PERMITTED DESIGN

PERMIT REVISION

LEVEL 6

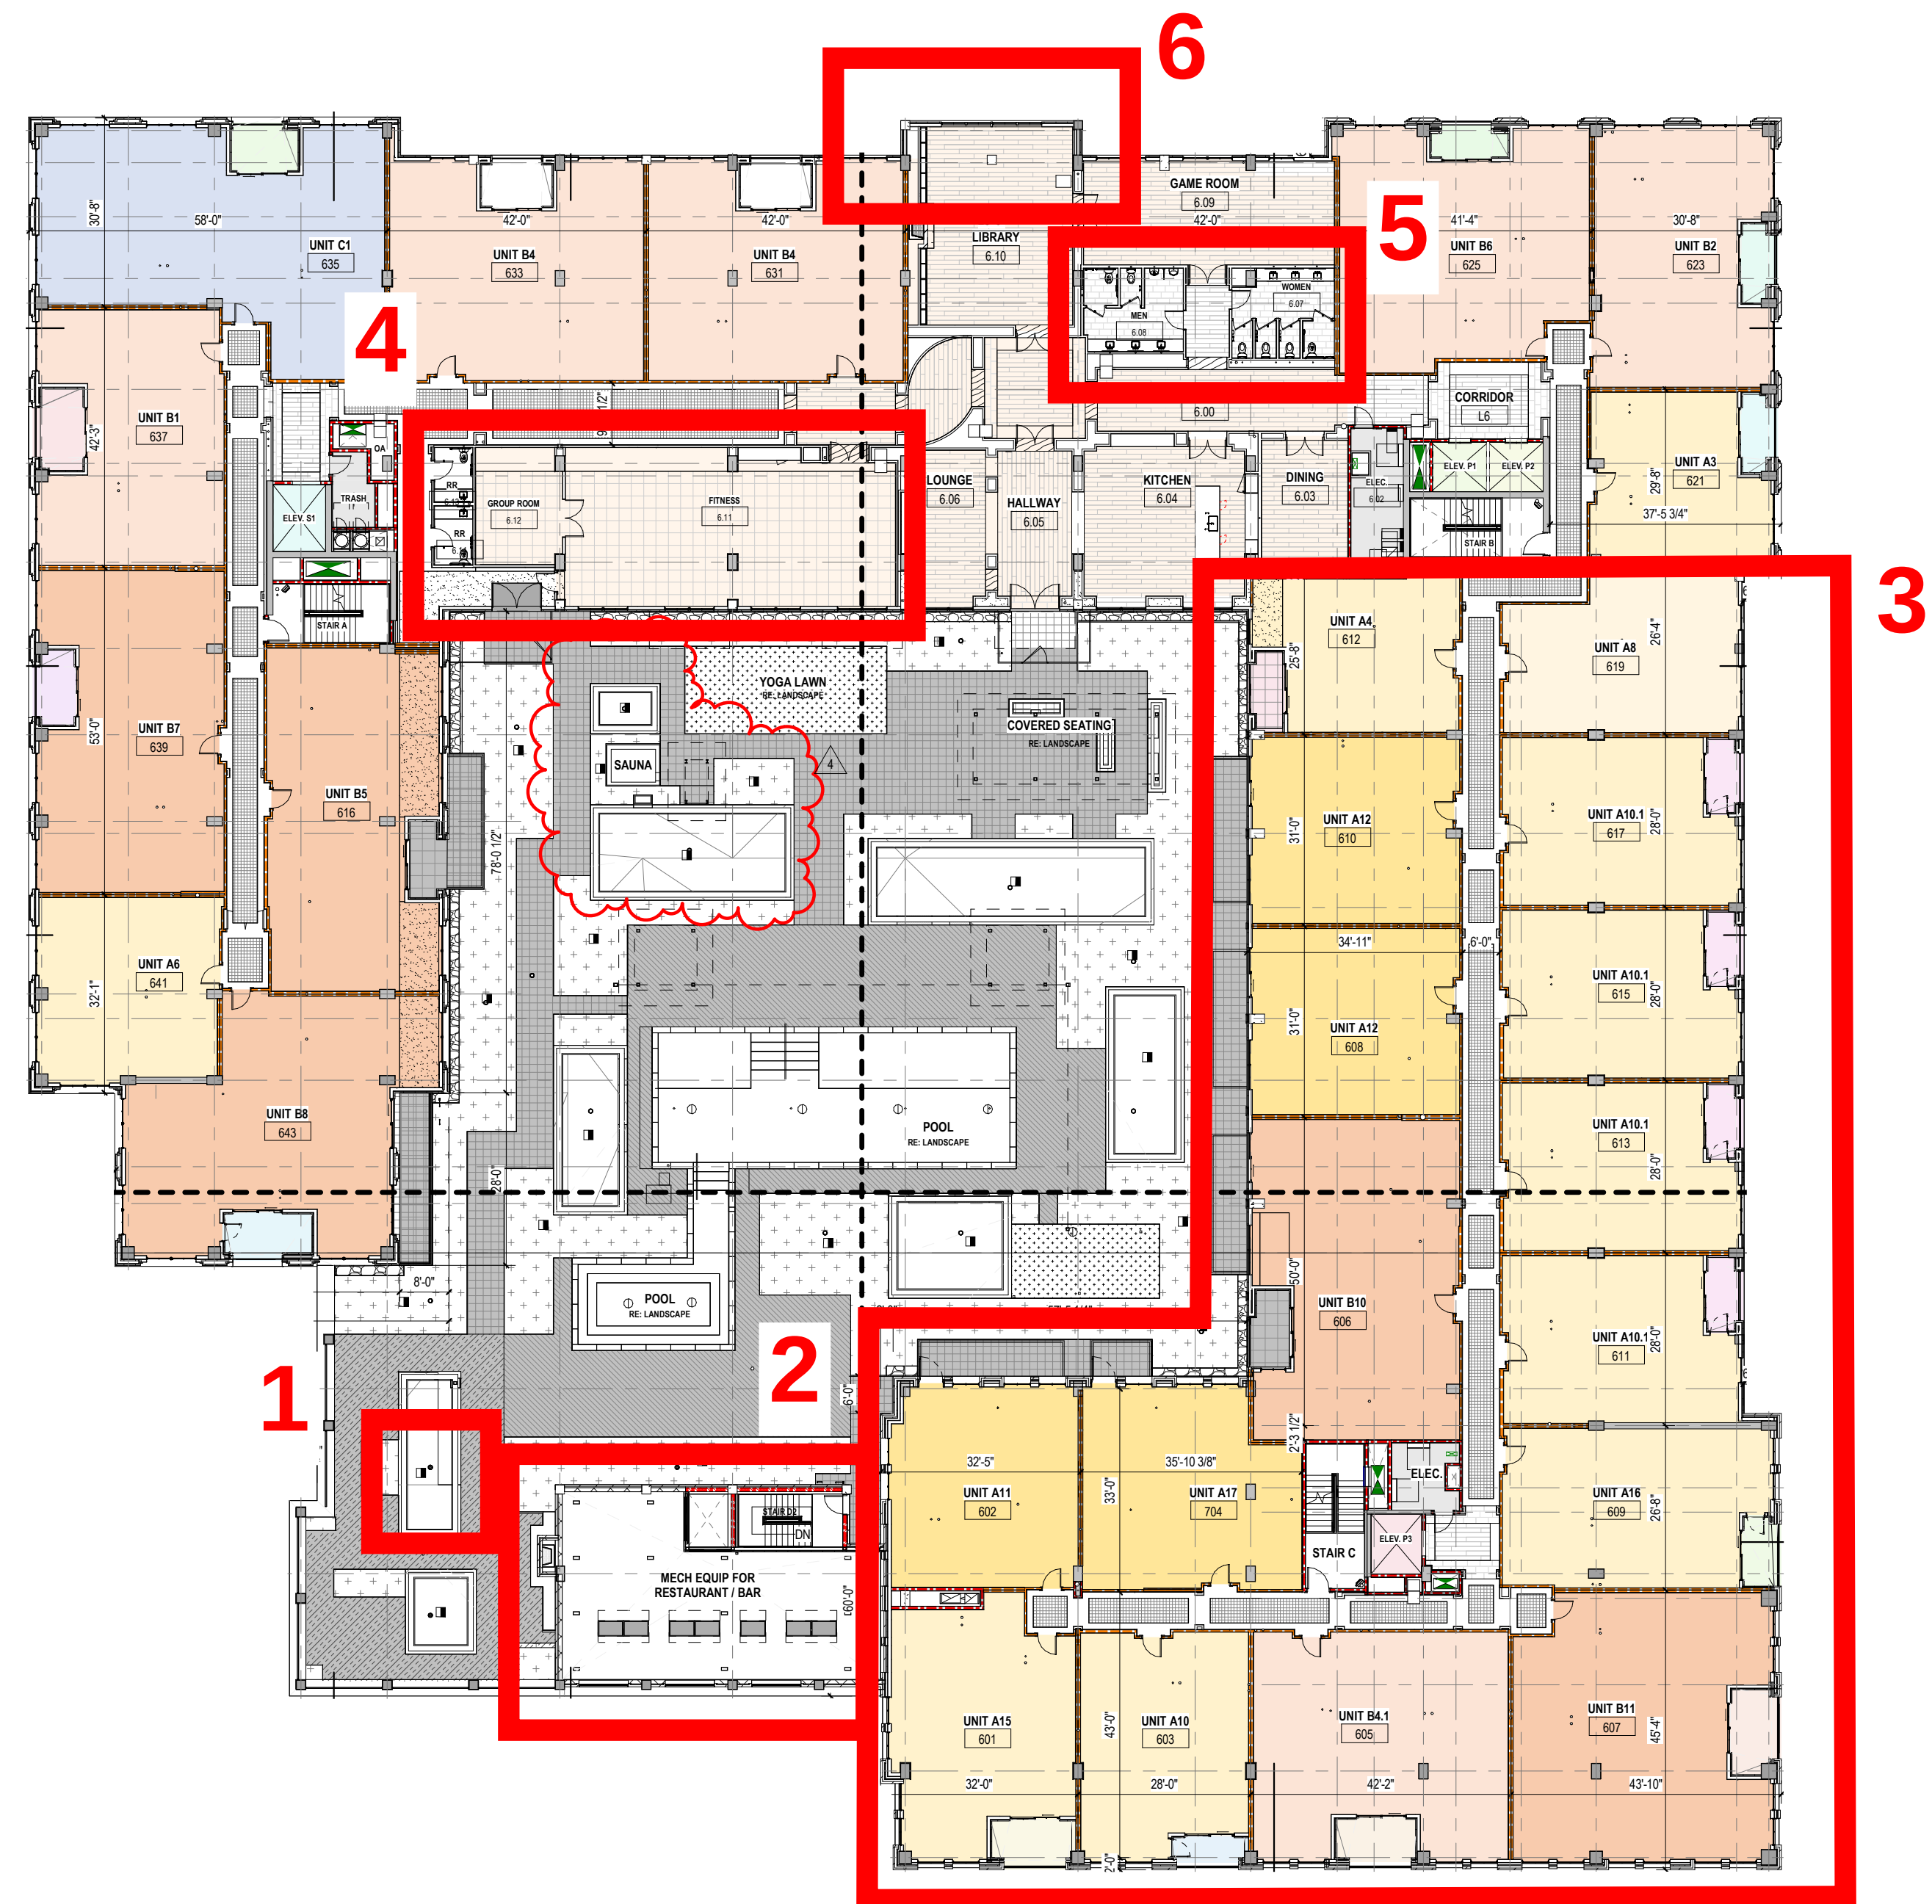
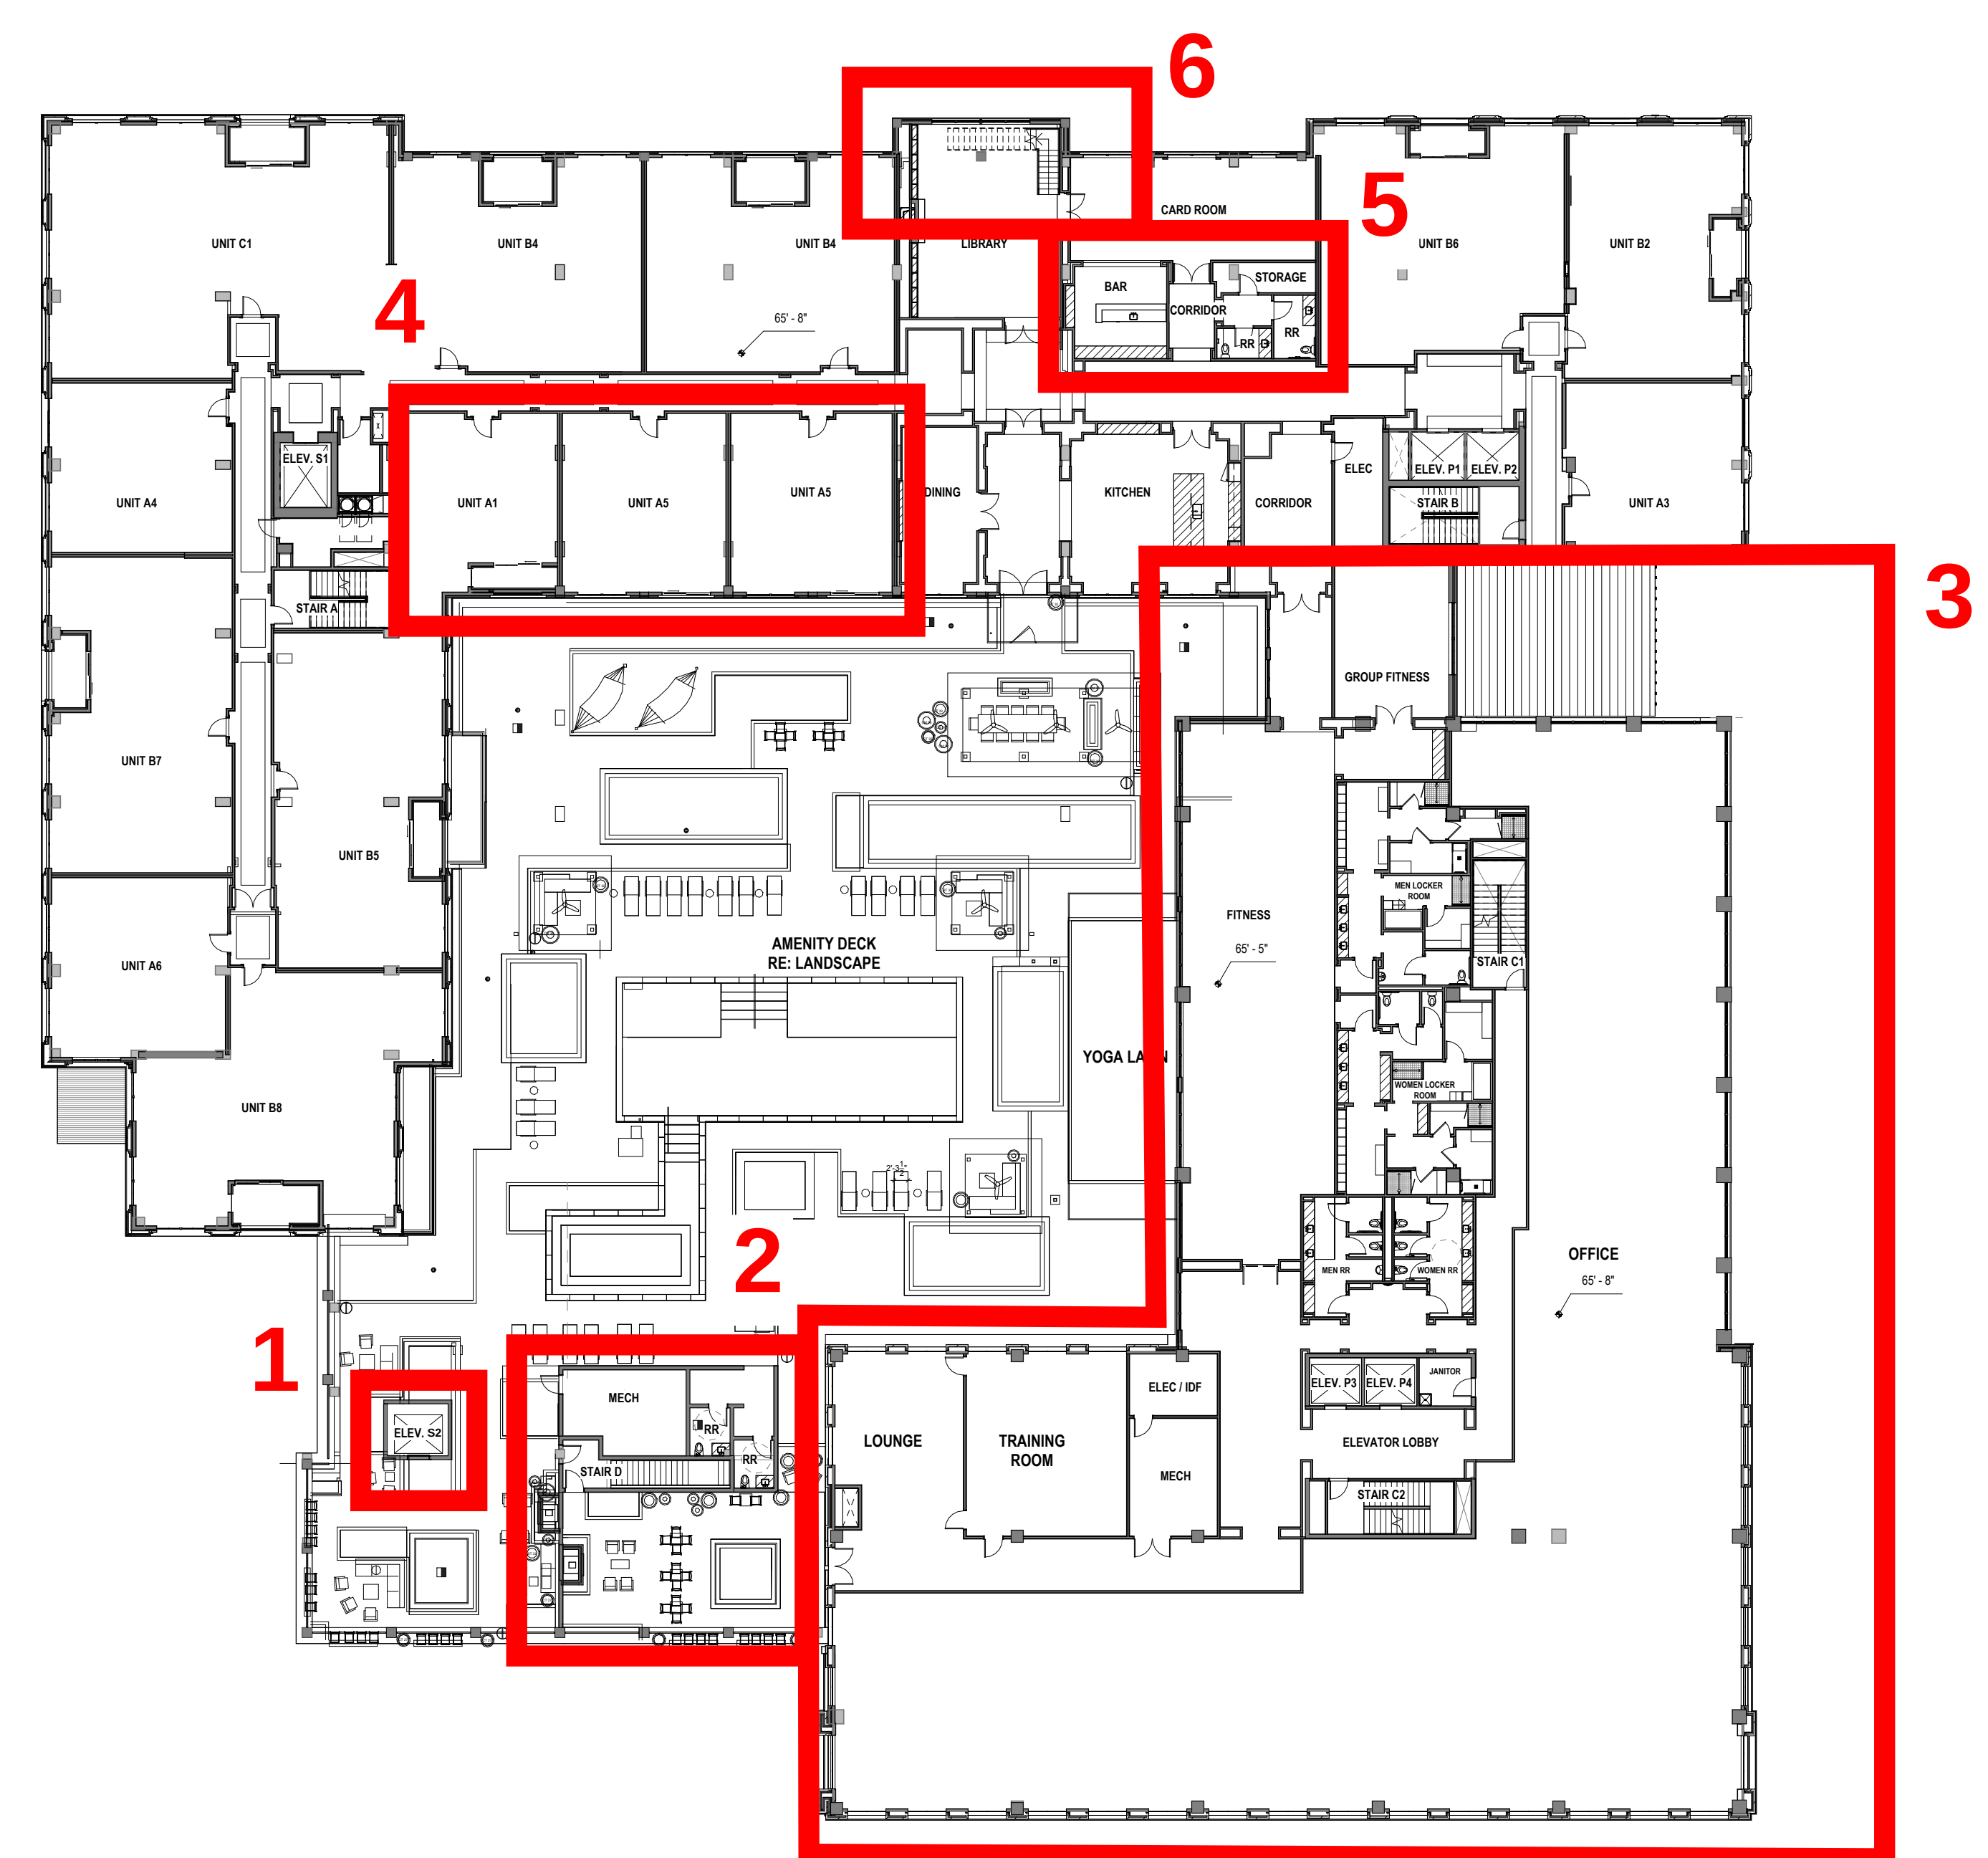
REVISIONS:

1. Added an elevator stop on the amenity deck.
2. Shifted mechanical space north to create an office amenity space.
Added (2) uni-sex restrooms.
3. Changed apartment units into office with dedicated office core (elevators, stairs, bathrooms, mechanical, and electrical).
Relocated fitness center to be shared with office. Created locker rooms.
Creating office building amenities (lounge, training room).
4. Relocated fitness and restrooms to office side. Replaced fitness with units.
5. Relocated restrooms to locker rooms. Replaced with a bar, storage, and (2) unisex restrooms.
6. Added a stair between the two levels of the library.
